**Southern
Water**

Your ref
BR/180/19/PL

Proposal: Erection of demountable/removable commercial unit at front facing London Road with residential unit at rear.

Site: BR/180/19/PL: - 37, London Road, Bognor Regis, PO21 1PQ.

ARUN DISTRICT COUNCIL BR/180/19/PL

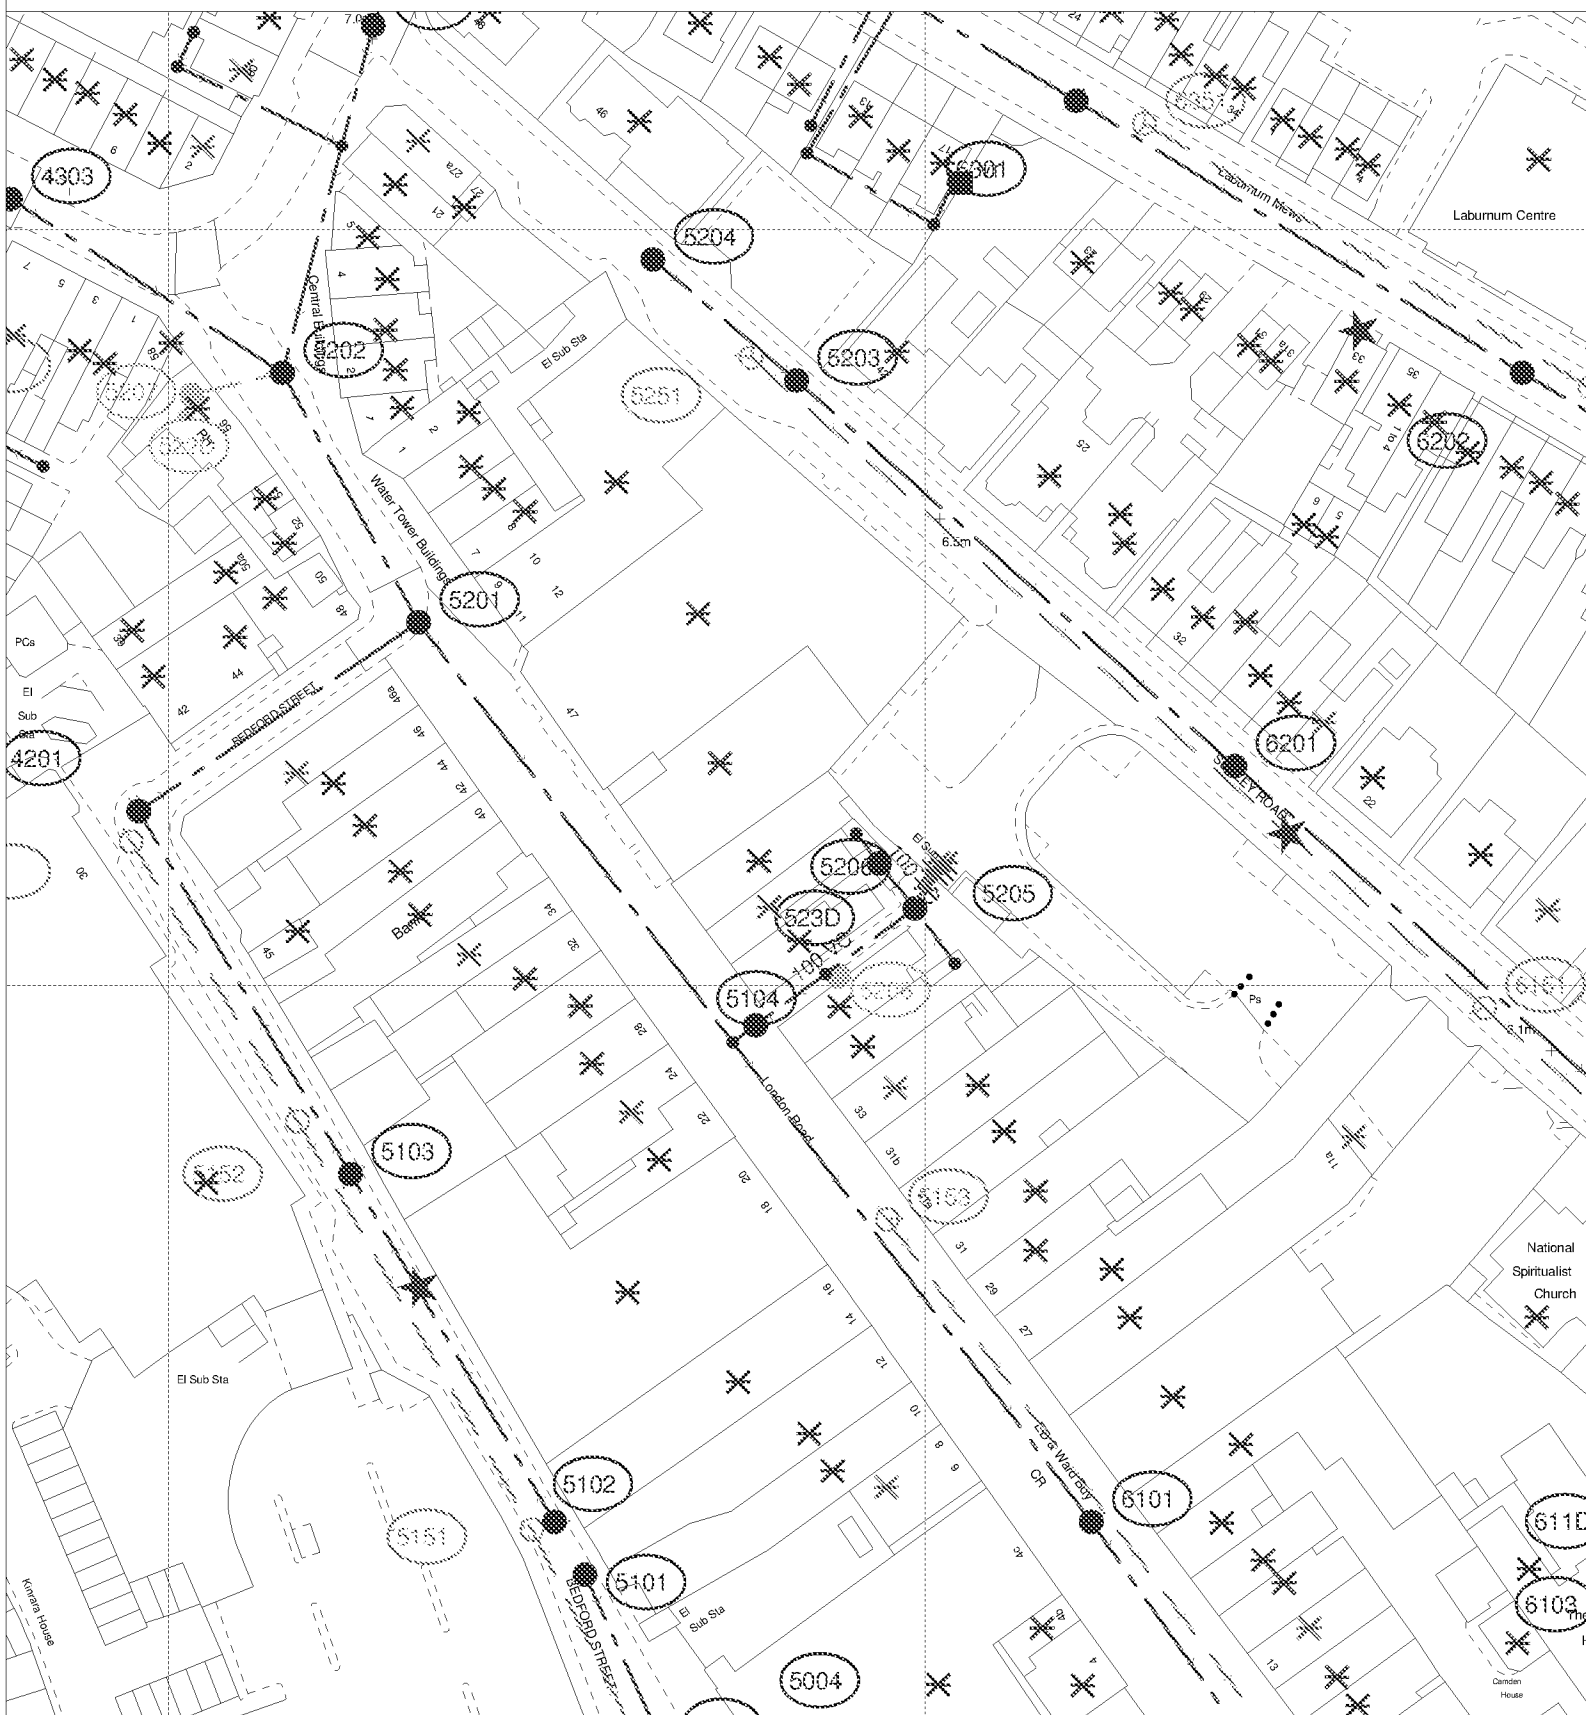
Please find attached a plan of the sewer records showing the approximate position of a public foul sewers within the site.

It might be possible to divert the public sewer, so long as this would result in no unacceptable loss of hydraulic capacity, and the work was carried out at the developer's expense to the satisfaction of Southern Water under the relevant statutory provisions.

1. The 100 mm diameter sewer requires a clearance of 3 metres either side of the sewer to protect it from construction works and allow for future access for maintenance.
2. No development or new tree planting should be located within 3 metres either side of the external edge of the public sewer.
3. No new soakaways should be located within 5m of a public sewer.
4. All other existing infrastructure should be protected during the course of construction works.

Alternatively, the applicant may wish to amend the site layout, or combine a diversion with amendment of the site layout. If the applicant would prefer to advance these options, items (1) – (4) above also apply.

In order to protect the foul sewer, Southern Water requests that if consent is granted, a condition is attached to the planning permission; for example, the developer must agree with Southern Water,

prior to commencement of the development, the measures to be undertaken to divert the public sewer.
